**TOWNSHIP OF SOUTH GLENGARRY**  
**GLEN WALTER ELEVATED WATER STORAGE**  
**TANK CONTRACT NO. 122083 (2024-14)**

**ADDENDUM NO. 1**

VALVE ROOM PLATFORM PLAN

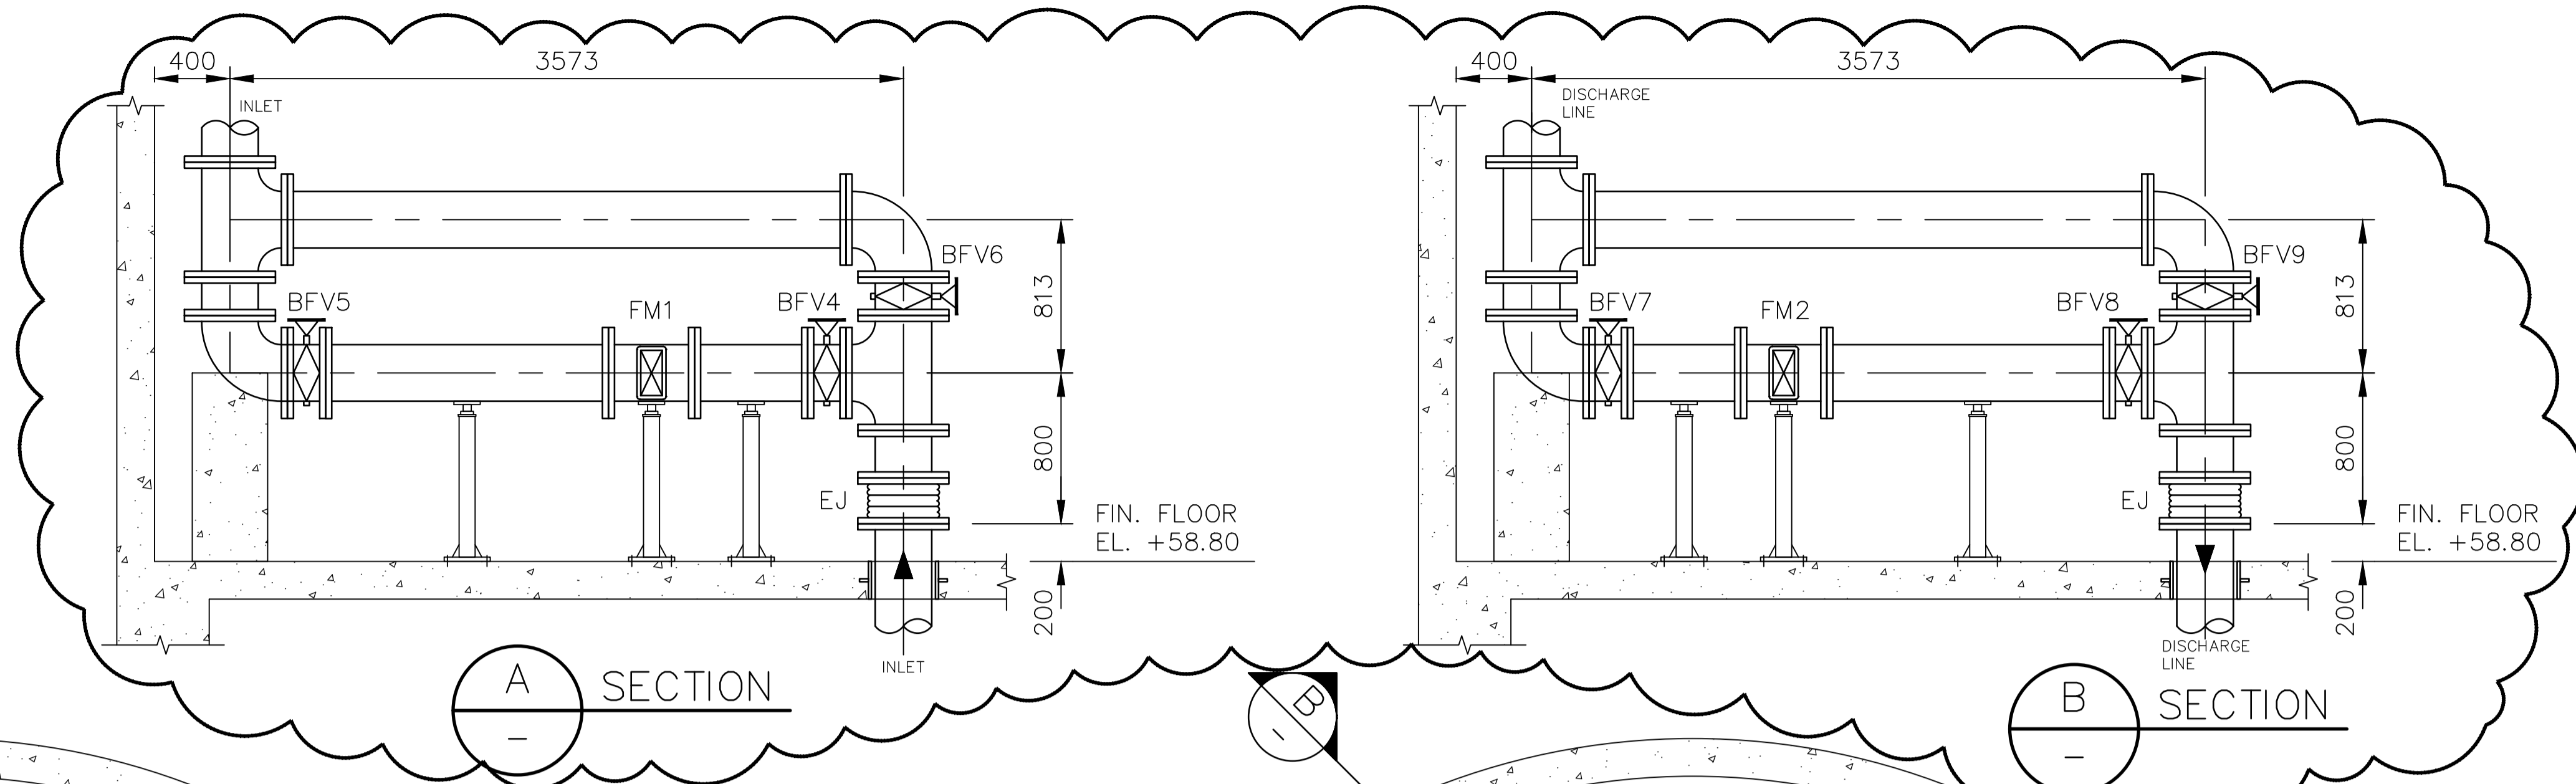
1. Add bypass piping around both flow meters (inlet and outlet) as shown on revised Drawings P1 (Process Flow Diagram) and P4 (Process Valve Room Platform and Interior Roof Plans): All piping, valves, heat tracing and insulation is to be in full accordance with the Specifications. Drawings are appended.
